Access Compliance Report Public Rights-of-Way (Curb Ramps)

Main Street: WENDOVER_RD		Cross Street: WEST_KNOLL_DR		Location:	NW
ADA ID: RPAT211115134324	Ramp Type:Type 1 - Perpendicular Diagonal Initial Pass/Fail: Pass		Overall Compliance: No	Severity Score:	2
Codes/Mitigation Info/Possible Solution			Field Measurements/Component Compliance

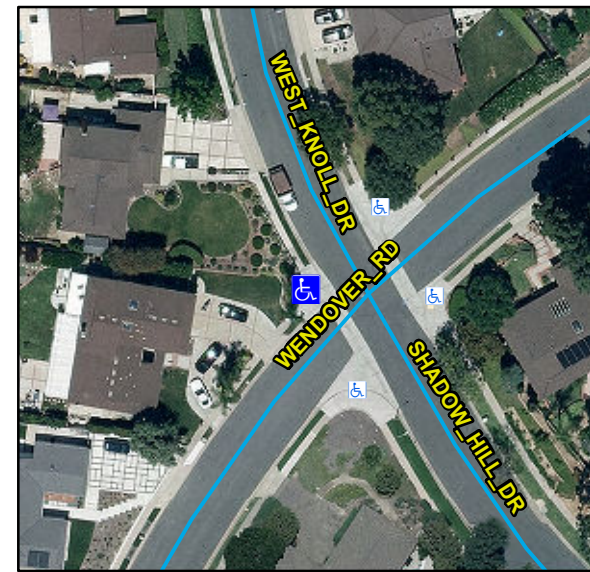
R304.2.2, R304.2.1, STD 1115

Remove & Replace Curb Ramp With Two New Directional Ramps or Equivalent.
